PROPOSED TE PŪTAHI LADIES MILE PLAN VARIATION

RESPONSE OF STUART JAMES DUN ON BEHALF OF THE QUEENSTOWN LAKES DISTRICT COUNCIL

Response to matters raised during the Hearing

Figure 1: Proposed amendments to AHFT plan

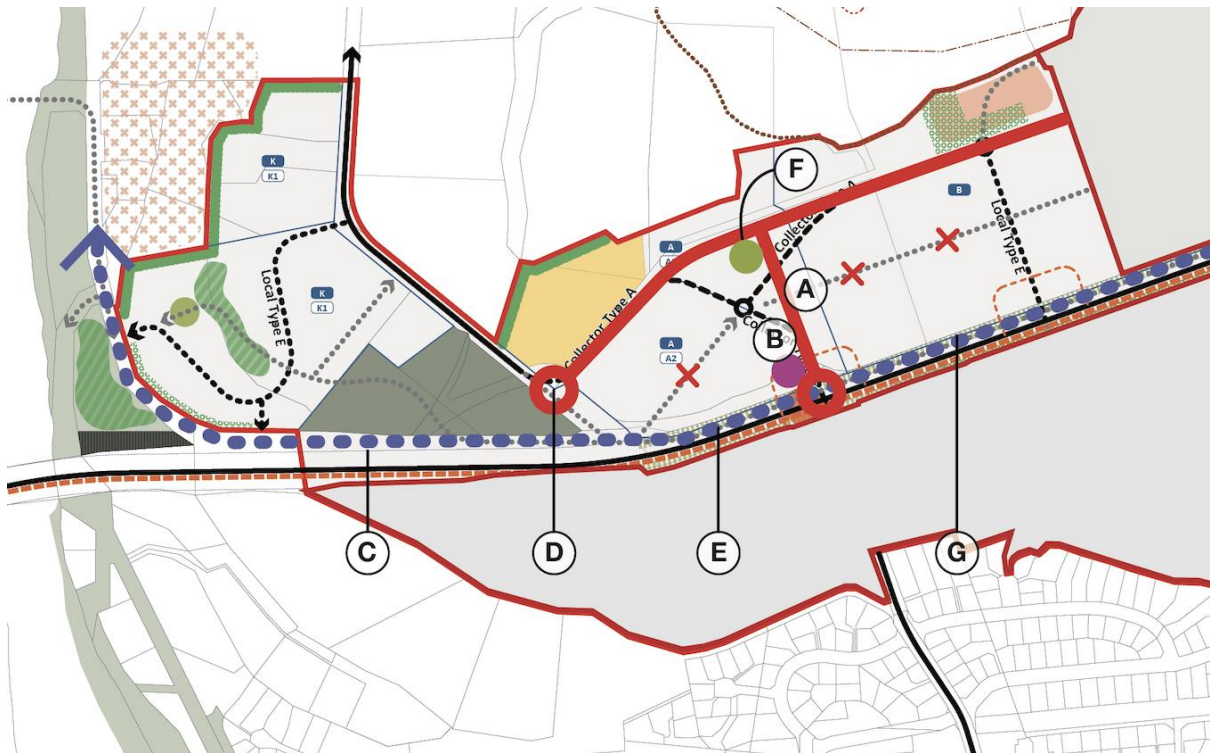
- 11 Following the hearing, experts for the Anna Hutchinson Family Trust (**AHFT**) have produced a revised Structure Plan indicating the revised relief sought by AHFT. Mr Harland, Mr Lowe, and myself have reviewed these plans and recommend the following amendments, should the Panel be of a mind to include the AHFT land in the TPLM Variation:

- (a) Maintain the Stalker Road extension perpendicular to SH6 until it meets the Collector Road A. This will maintain sight lines to the toe of Slope Hill.

- (b) Reduce the size of the commercial zone to reflect the scale that the economic experts can support, and locate this adjacent to the proposed bus stop on SH6.

- (c) Maintain the active travel link along Spence Road, rather than through the cemetery. At the eastern point of the cemetery commuters can elect to continue along SH6 or connect with Collector Road A.

- (d) Provide for an intersection where Collector Road A joins Lower Shotover Road as traffic will still need to access Spence Road.
 - (e) I note also that the AHFT plan shows an active transport link on the south side of SH6 which is inconsistent with the proposed structure plan which anticipates an active travel link on both sides of the highway – within the Amenity Access Area on the north side. The midblock cycleway should also be removed with formal active travel links already provided along SH6 and Collector Road A.

- (f) Locate the neighbourhood park at the intersection of Collector Road A and the Stalker Road extension.

- (g) The AHFT plan indicates a 12m Amenity Access Area. As discussed above our proposal is for a 16.5m Amenity Access Area.

Appendix A – Revised Amenity Access Area Plans

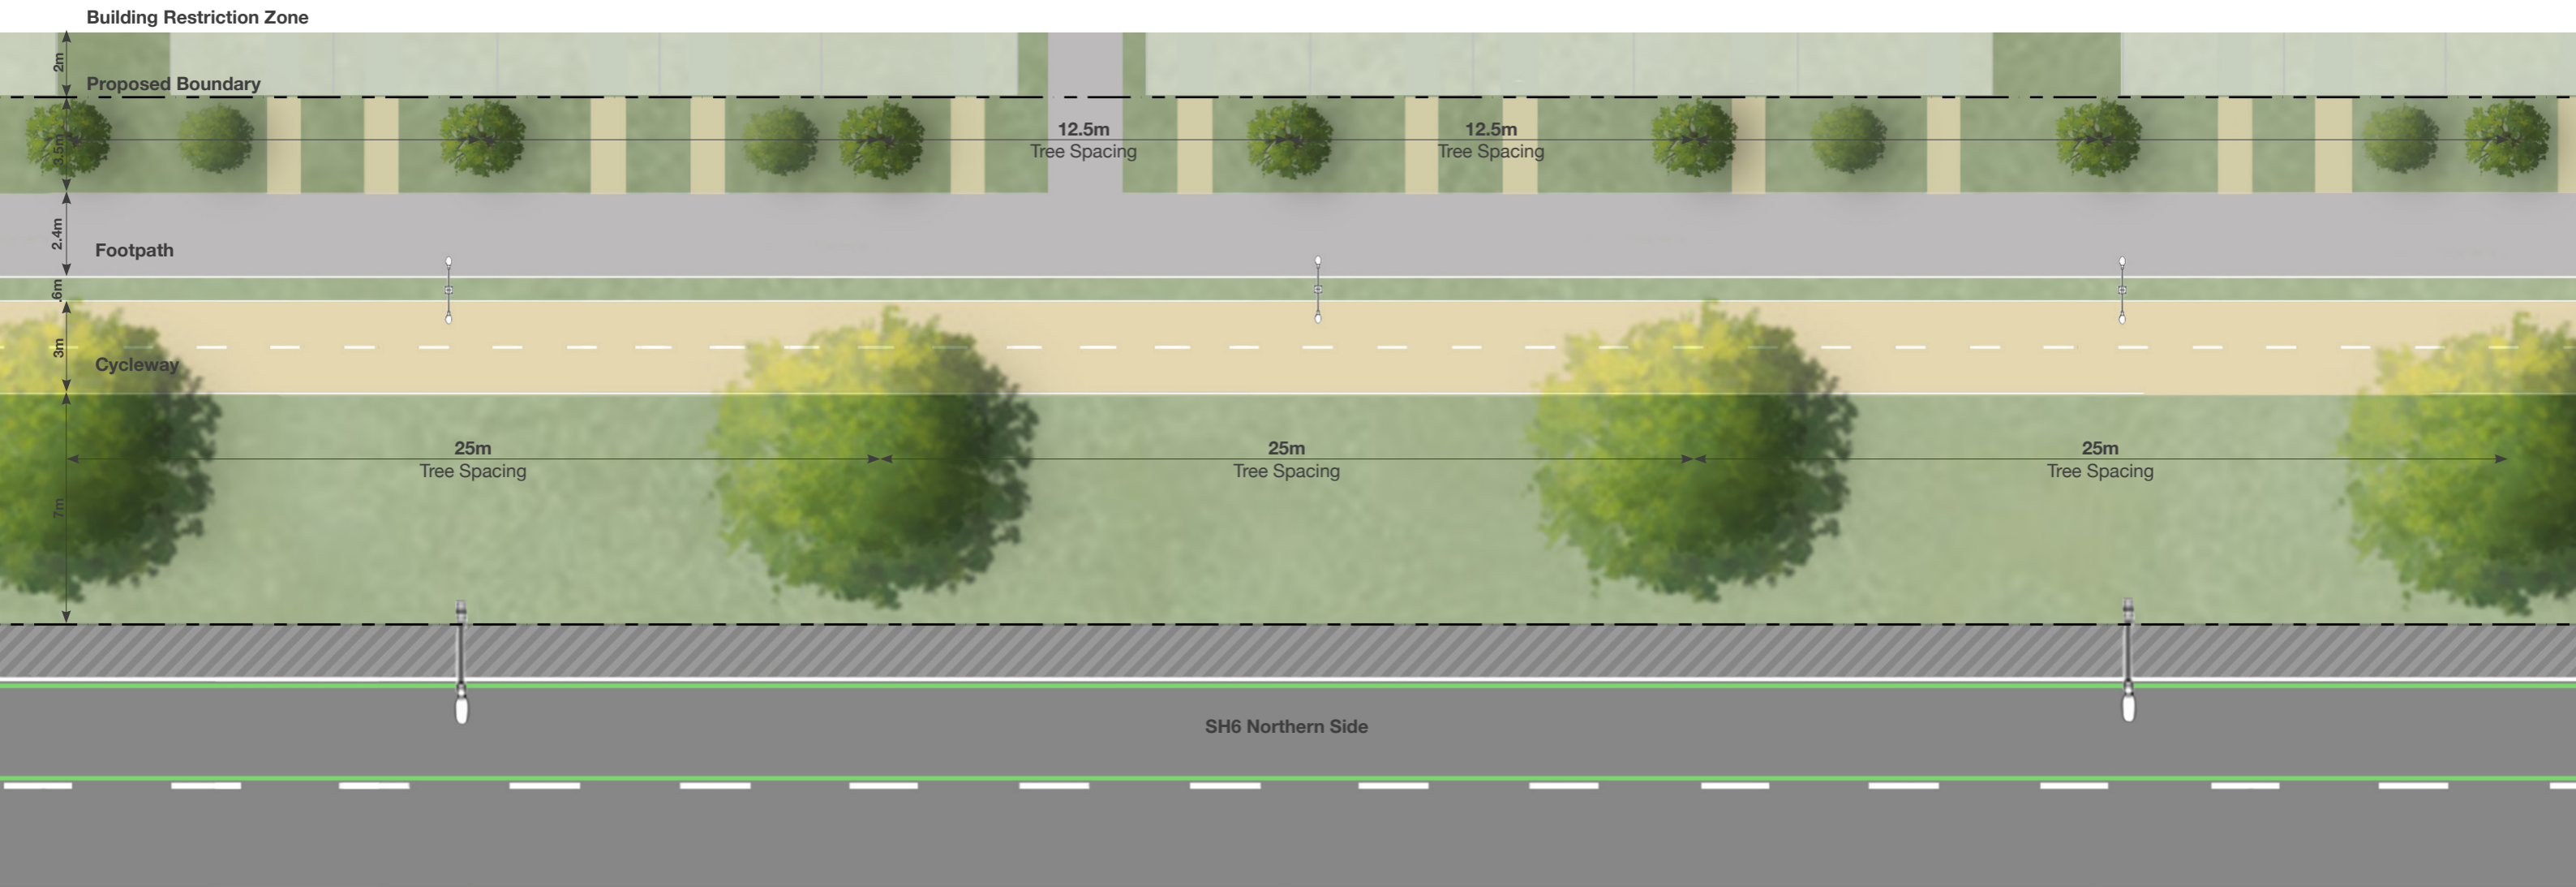
- 3 The detail and dimensions of the proposed Amenity Access Area to the north of State Highway 6 (**SH6**) were debated and discussed at length throughout the hearing. Following the hearing, the Council's urban design experts, including myself, have proposed a further reduced cross section (18.5m building restriction, 16.5m Amenity Access Area) and provided an additional part plan and elevation to set out the spacing of proposed specimen trees. These drawings respond to questions raised by the Panel and were circulated to submitters' experts for comment on 21 December 2023. Submitters' responses to these revised plans are attached to legal counsel's closing submissions at Appendix B. I attach these revised plans as **Appendix A**.

- 4 The tree species proposed for the north side of SH6, directly adjacent to the state highway, are large scale deciduous trees that have been selected to complement the existing Chestnut trees on the south side, reflect the character of the wider Wakatipu Basin, and create a consistent and distinctive arrival experience. The scale of these trees is reflective of the rural and agricultural character of the wider region and space is provided within the proposed cross section for these trees to mature. The spacing of these trees at 25m centres provides for a consistent landscape treatment whilst maintaining views between them to the development behind, and clearly signalling an urban environment. As the trees mature clear views under the canopy to the urban environment will also be provided. As the trees are deciduous the impact of shading of the highway in winter months is also reduced.

- 5 The second row of trees, adjacent to the boundary, is proposed to be a mix of native species that support the ecological aims to increase and support biodiversity. These smaller scale trees will also be complemented with low level planting and the rhythm of tree planting can be structured to respond to the adjacent development and maintain views.
